South Texas Project Electric Generating Station P.O. Box 289 Wadsworth, Texas 77483

October 20, 2016
NOC-AE-16003401
10CFR50.12
10CFR50.90

South Texas Project
Units 1 and 2
Docket Nos. STN 50-498 and STN 50-499
Supplement 3 to Revised STP Pilot Submittal and Requests for Exemptions and
License Amendment for a Risk-Informed Approach to Address
Generic Safety Issue (GSI)-191 and Respond to Generic Letter (GL) 2004-02
(TAC NOS. MF2400 - MF2409)

Figure 52-1: Debris Introduction Drop Zone for Non-Chemical and Chemical Debris

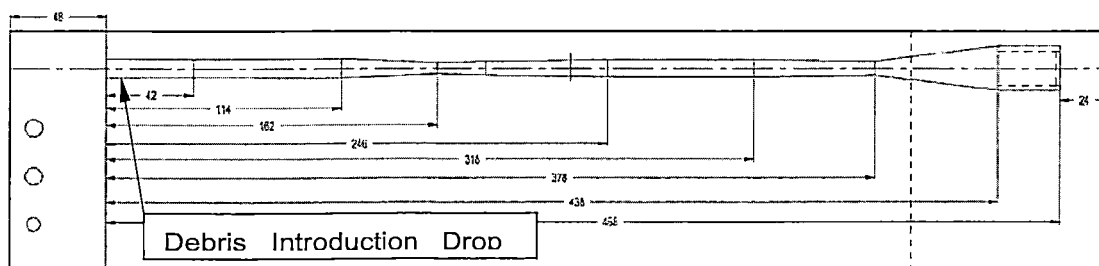
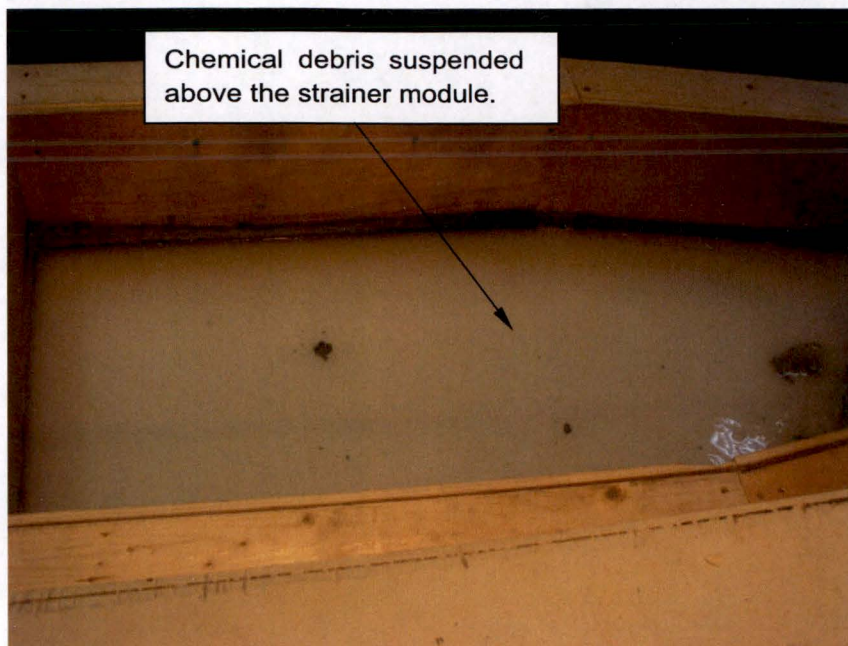
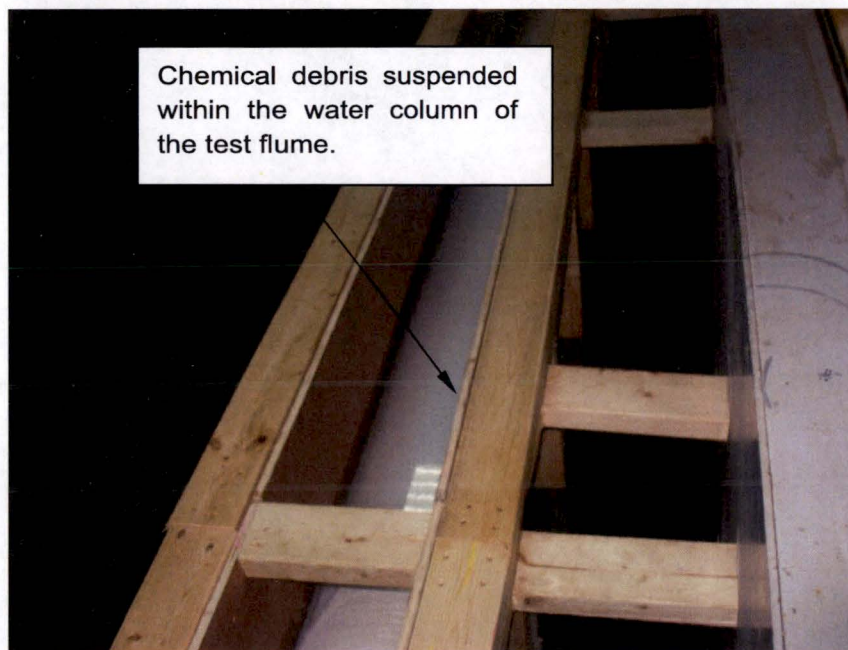
The licensee performed integrated head loss testing in a flume by adding chemical precipitates after other non-chemical debris. The NRC staff questions the transport of the calcium phosphate precipitate during the test since the plant's trisodium phosphate basket location relative to the sump strainers varies and in some cases may be less than the distance from the precipitate introduction point to the strainer section in the test flume. The staff also questions if fibrous debris settlement within the narrow cross section of the test flume may create a pile of fiber that filters the calcium phosphate precipitate in a non-conservative manner since this precipitate settles more rapidly than the aluminum based precipitate. Given this concern, please justify why the head loss testing was appropriate in terms of calcium phosphate precipitate transport to the test strainer.

Revised Response to RAI #52

Based on the PCI / AREVA NP test protocol (52.1), the chemical debris surrogates are introduced into the test flume through the surface of the water at the upstream section of the test flume (see Figure 52-1 below). From visual observation, the chemical debris was observed to be transported to the strainer module. This was based on the gradual change in opacity of the water after the chemical debris was introduced into the test flume. After all of the chemical debris was added, the opacity of the flume water stabilized and remained constant during the remainder of the test. See Figure 52-2 and Figure 52-3 for chemical debris that was suspended in the water column within the test flume all the way up to the location of the test strainer module.

Both aluminum oxyhydroxide and calcium phosphate were generated for the STP design basis test in accordance with the acceptance criteria presented in WCAP-16530-NP (52.3). Though Figure 52-2 and Figure 52-3 show the chemical precipitate in suspension, it is difficult to visually distinguish between aluminum oxyhydroxide and calcium phosphate since both have a similar indistinguishable 'milky-white' color.

Figure 52-4: Location of TSP Baskets Located in STP Containment

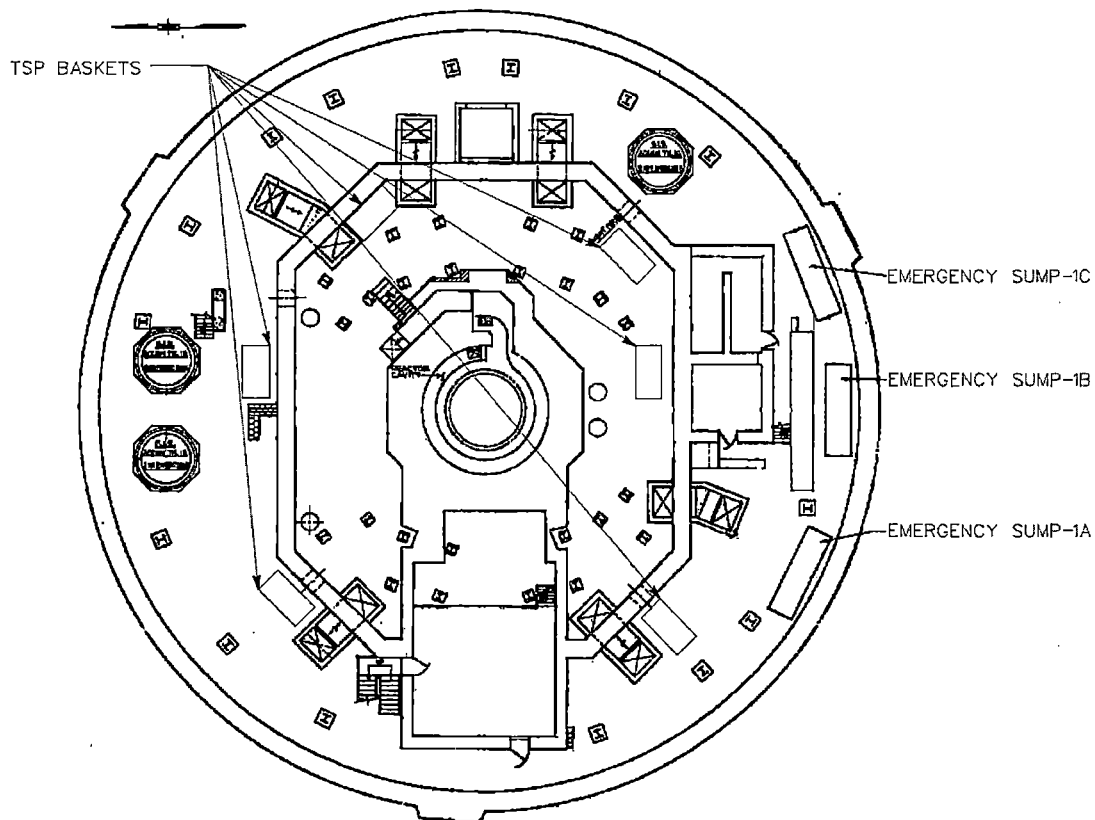
Figure 52-4 shows the locations of the TSP baskets located in STP containment. One TSP basket is located in close proximity to the ECCS sumps. This has caused concern with the NRC Staff, regarding the non-conservatism associated with the introduction zone of chemical debris (i.e., calcium phosphate) relative to the location of the test strainer. Since chemical precipitates are expected to form during the recirculation phase, it is expected that most of the chemical precipitates would be dispersed throughout the containment (greater than the distance of the debris introduction zone relative to the strainer in the STP test flume configuration). This is based on the dissolution of the TSP during the initial high temperature post-LOCA period and subsequent flow into the strainers and ECCS. The combination of the ECCS and CSS would serve to both mix and distribute the dissolved TSP throughout the STP containment and prevent significant concentration in the immediate area of the strainers. Therefore, only a small portion of the total quantity of chemical precipitates is expected to form in the proximity of the ECCS strainers. The calculated total amount of calcium phosphate precipitant was then introduced into the test flume upstream of the strainer. Theoretically, even if some of the calcium phosphate precipitant were to settle or be artificially filtered out by the non-chemical debris upstream of the strainer, it is expected that the amount that reached the test strainer was greater than or equal to that of expected for the actual plant strainers. Under this basis, the STP test flume configuration is considered to be prototypical of the STP containment and the TSP basket locations are not a concern due to the mixing and distribution of the dissolved TSP by the combined ECCS and CSS.

The calcium phosphate transport was appropriately tested for STP head loss testing since calcium phosphate precipitate was generated per WCAP-16530 (52.3) guidance and sequenced in such a manner to prevent over concentration in the test flume, thus minimizing settling of the precipitate. Based on the total volume in the test flume and piping, one flume turnover is approximately 5 – 6 minutes. As seen in Figure 52-1, the distance between the drop zone and the front surface of the strainer module consists of a smaller volume of water compared to the total flume volume. Based on the volume between the debris drop zone and the front surface of the strainer module, it would take debris approximately 2 minutes to travel to the strainer once introduced into the test flume. Based on the STP Test Plan, there was one flume turnover between chemical introductions of aluminum oxyhydroxide and calcium phosphate, and two flume turnovers between consecutive batches of calcium phosphate. Thus, sufficient time was allowed between all batches of chemical precipitate to allow the precipitate to transport to the strainer prior to the next chemical introduction.

Figure 1. Steam Generator Nodalization and Passive Heat Structures (Sensitivity)

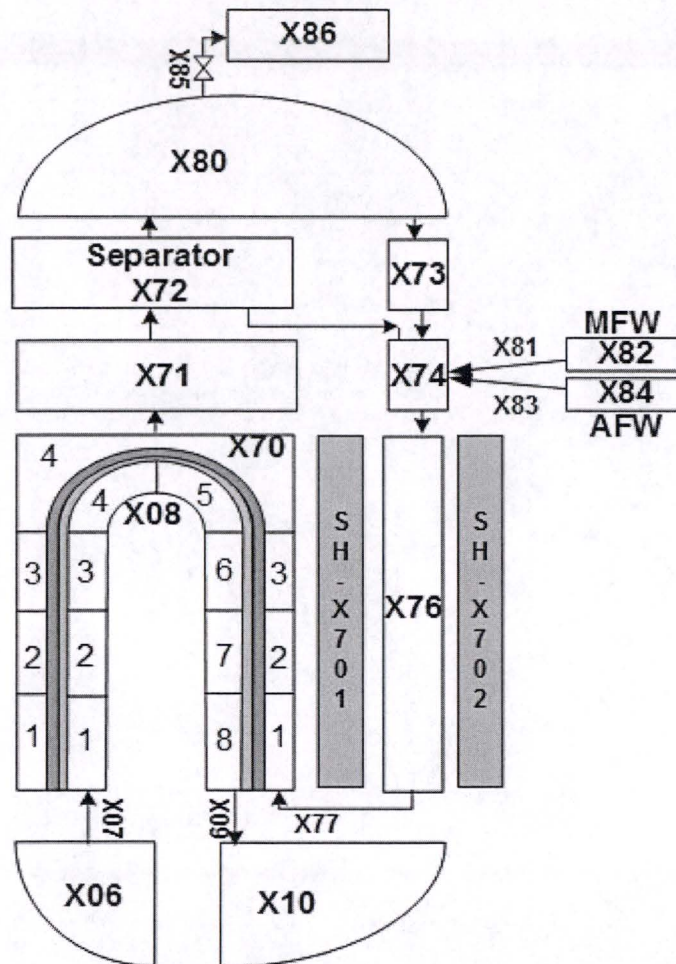
Initial RAI: *Provide a description of the accident progression of the accident scenarios being simulated using the LTCC EM. This description should start at the initiation of the break, define each phase, and the important phenomena occurring in that phase in the various locations of the RCS (e.g., core, reactor vessel, steam generators - both primary and secondary side, loops, pressurizer, pumps, containment)*

The total dry mass of the SG specified in the sensitivity model is equal to 1,045,000 lbm. This mass is equally split between two passive heat structures (SH- X701 and SH-X702) identified in Figure 1.

Since the SG U-tubes are simulated with a separate heat structure (see Figure 1, dark profile between X70 and X08), the mass of the U-tubes are accounted twice in the sensitivity model to increase conservatism.
